# UNITED STATES PATENT AND TRADEMARK OFFICE

APPLICATION NO.	FILING DATE	FIRST NAMED INVENTOR	ATTORNEY DOCKET NO.	CONFIRMATION NO.
10/532,277	04/21/2005	Andrea Drollinger	14150	8515

## Office Action Summary

## DETAILED ACTION

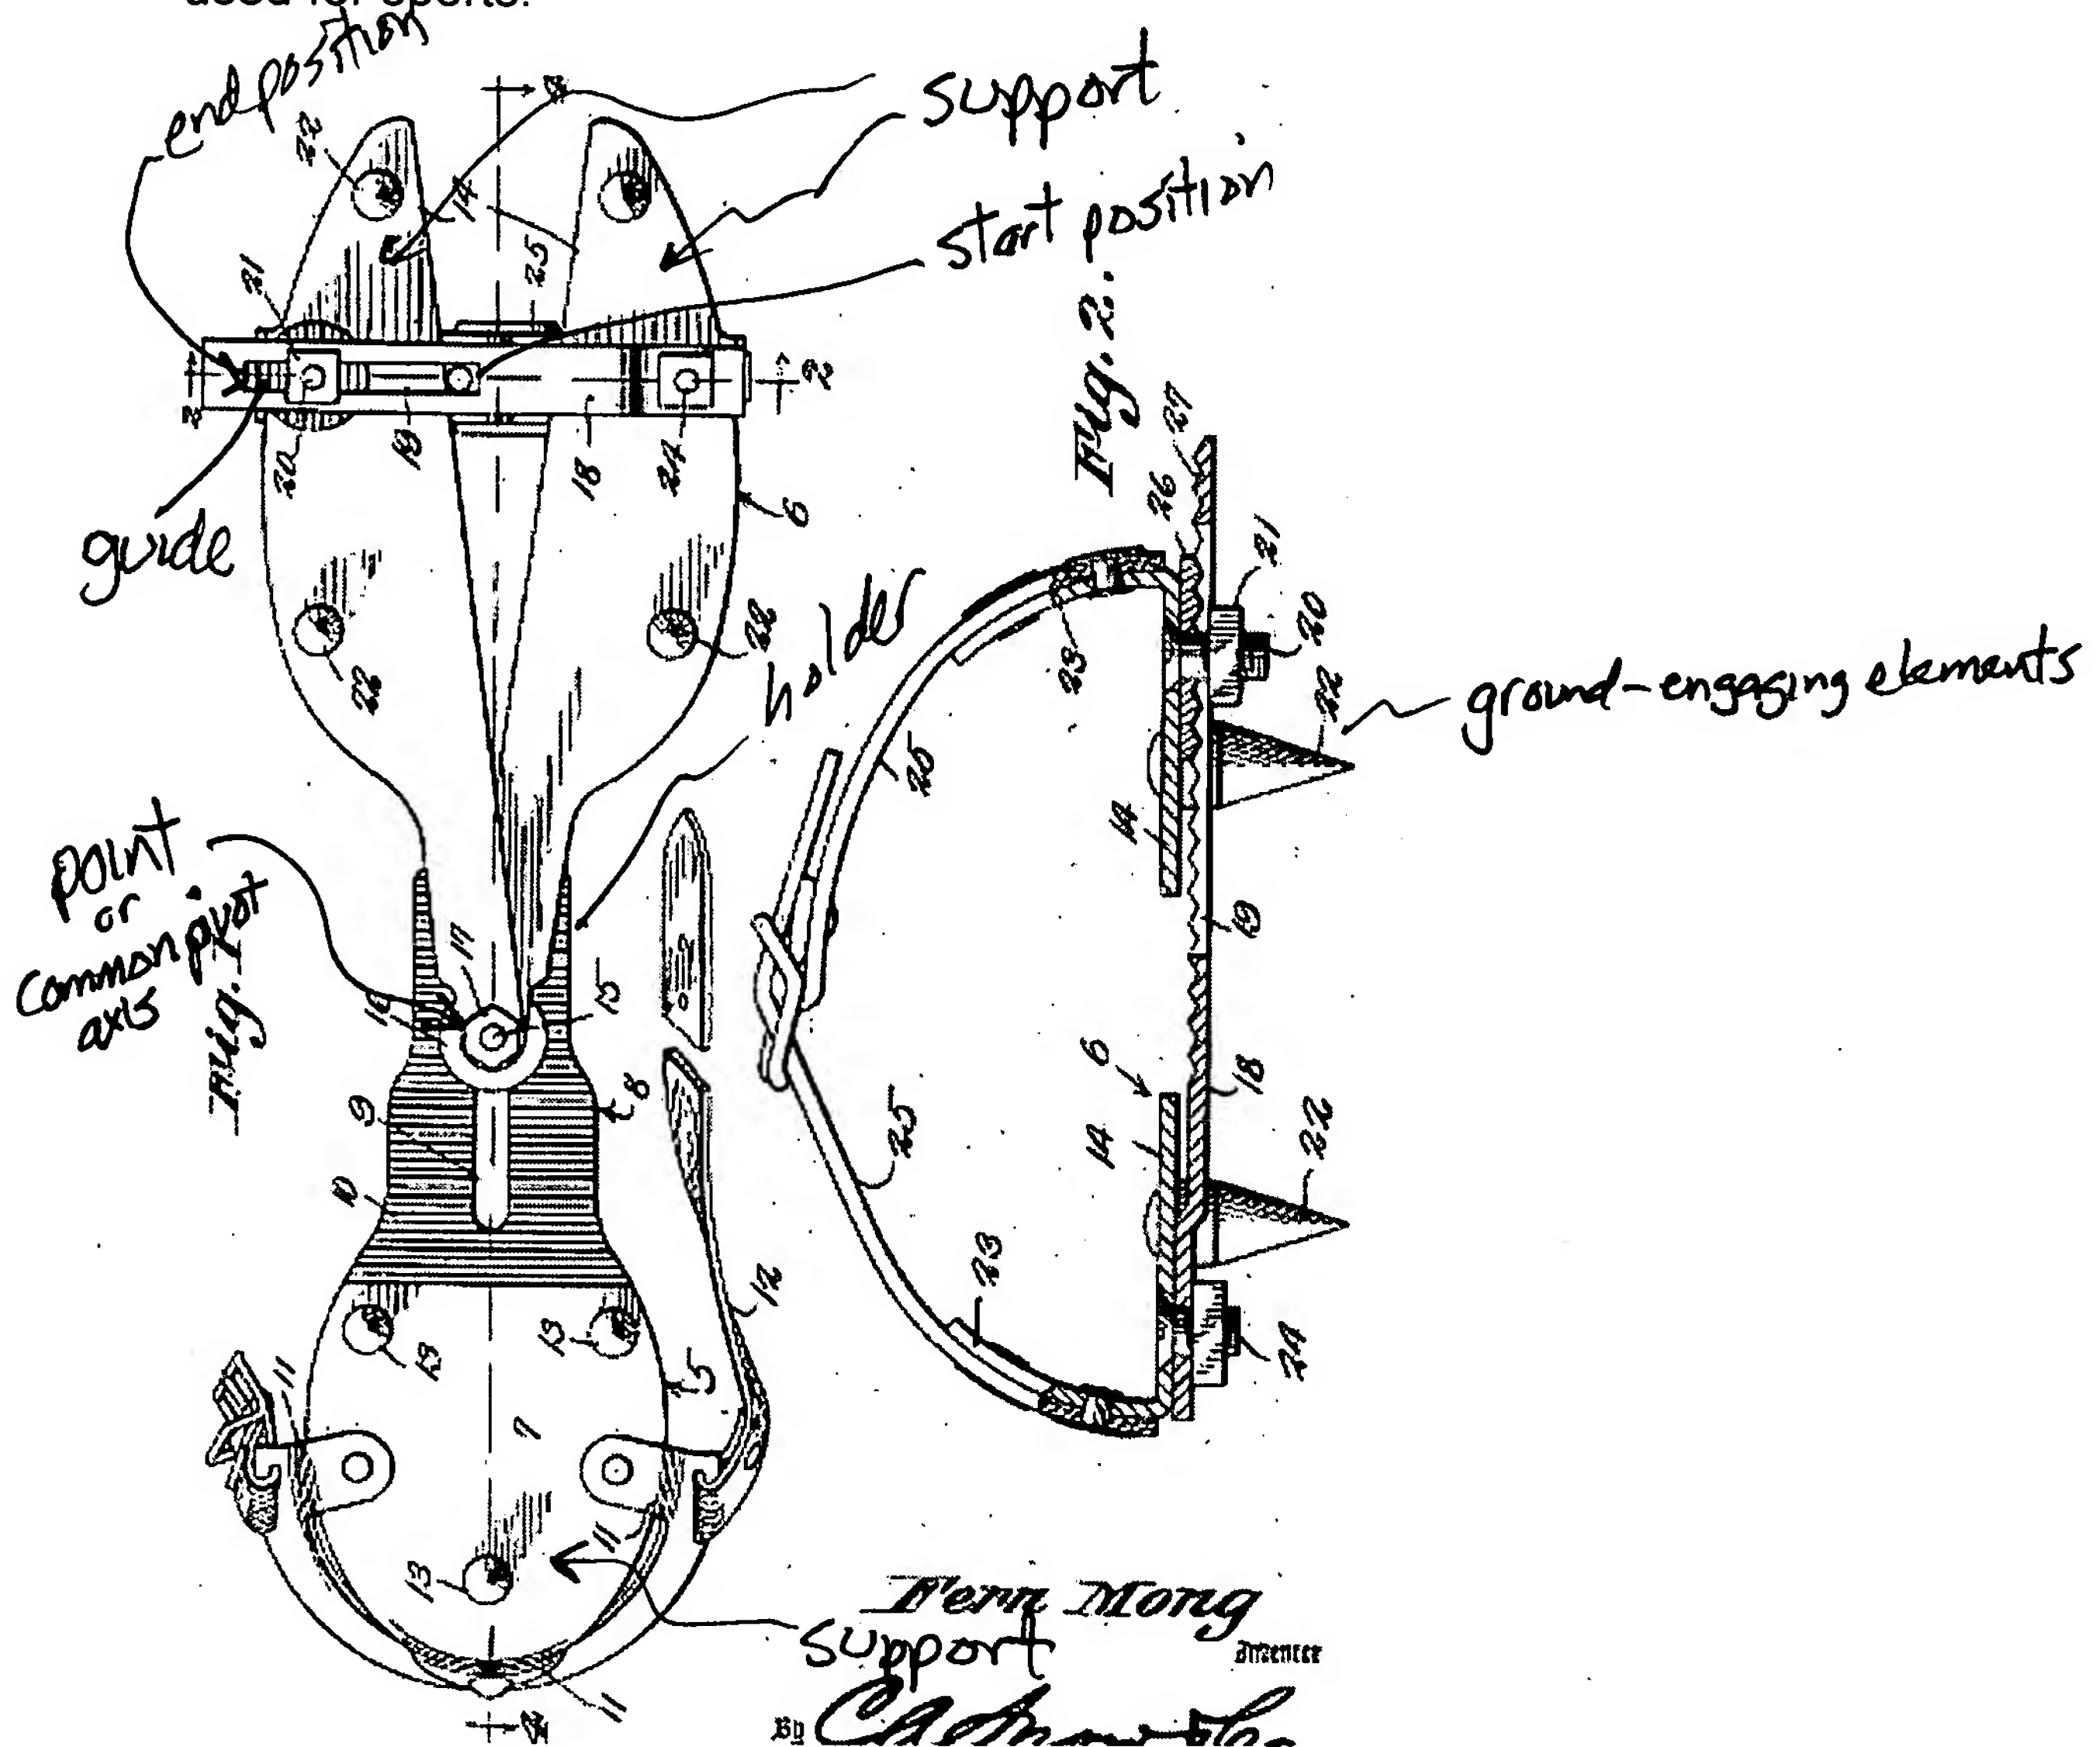
6. Claims 1-5, 11, 25-27, 48-56 are rejected under 35 U.S.C. 102(b) as being anticipated by US 2002706 (Mong).

Mong teaches an ice creeper (sole with downwardly projecting ground elements) which is detachably mounted on a shoe, wherein the ice creeper has two support plates with ground-engaging elements which are guided and held to move forward and backward along an arc; see the marked-up figure below. The shoe can inherently be used for sports.

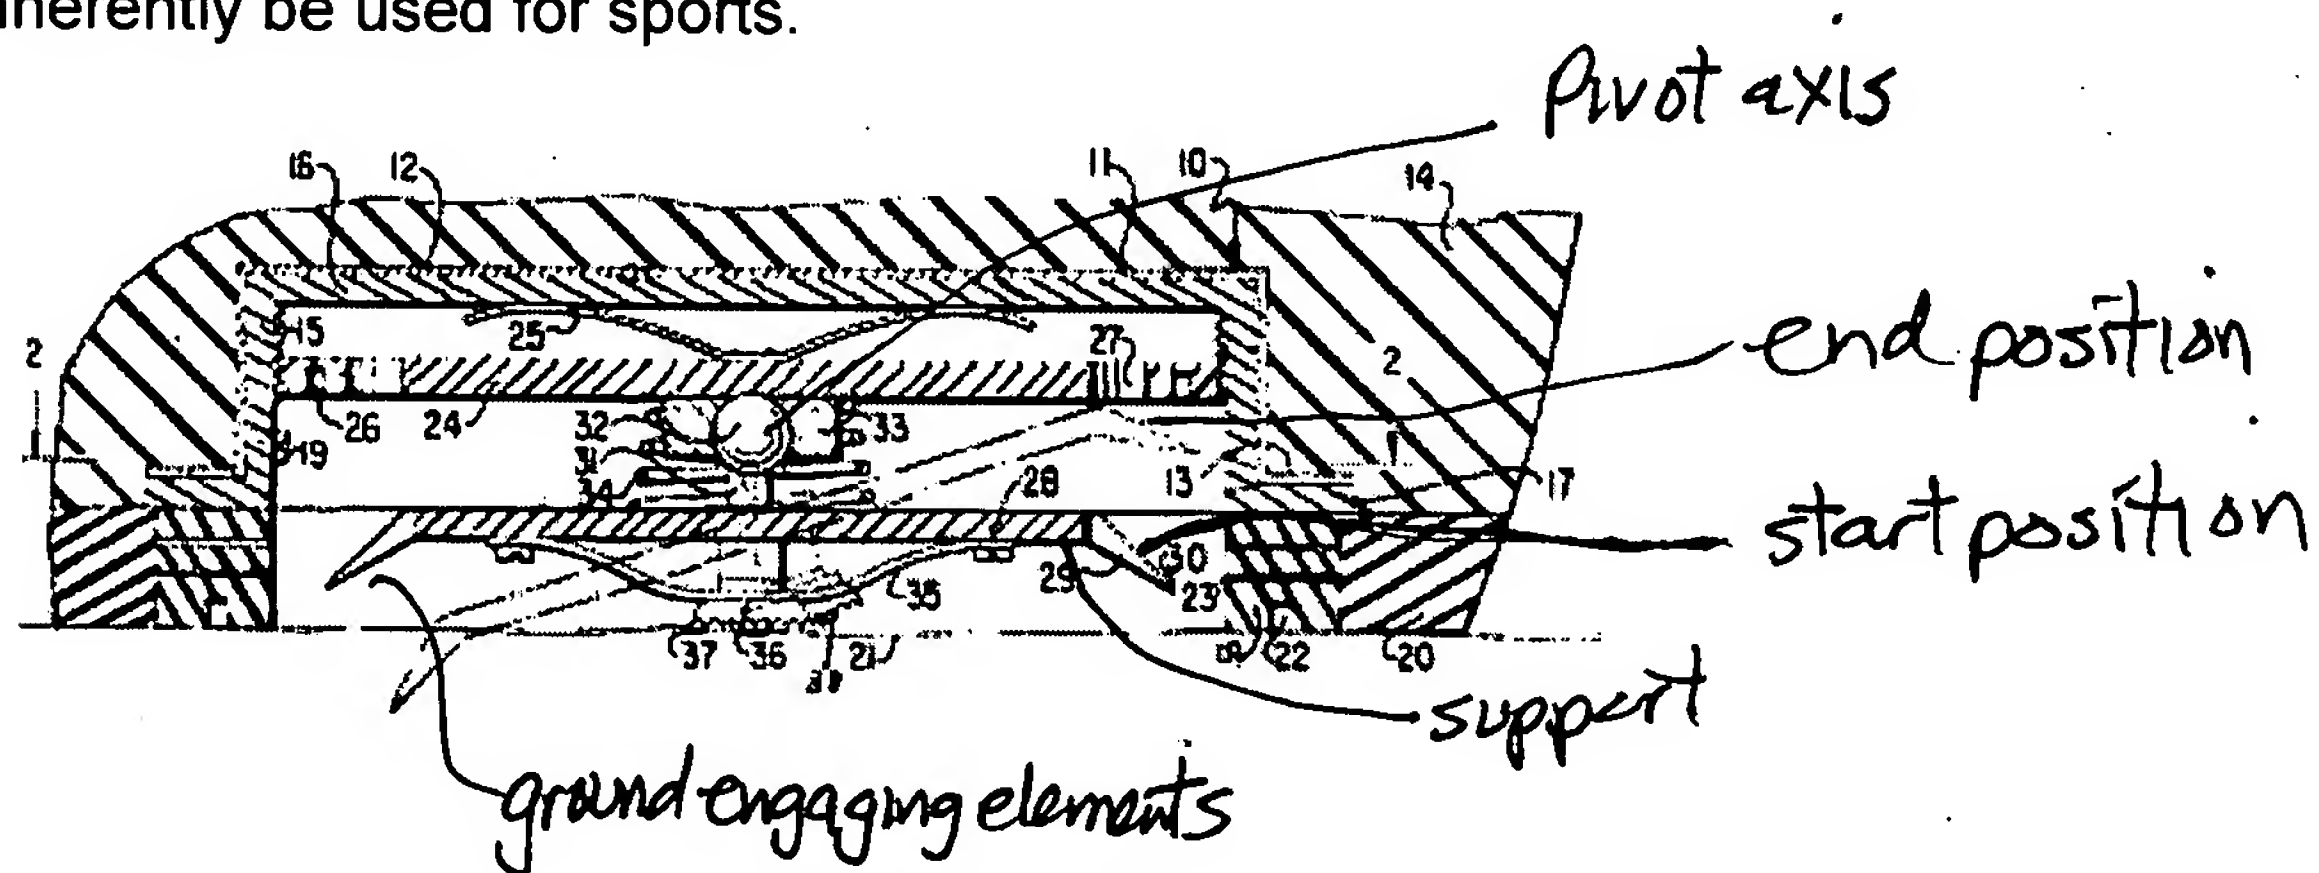
Rice teaches an antislip footpiece for a shoe having structure as claimed. See the marked-up figure below. The support (plate 28) with downwardly projecting ground-engaging elements (29) are guided and held to move forward and backward along an arc; figure 1 shows in dashed lines the plate moving about the arc. The shoe can inherently be used for sports.
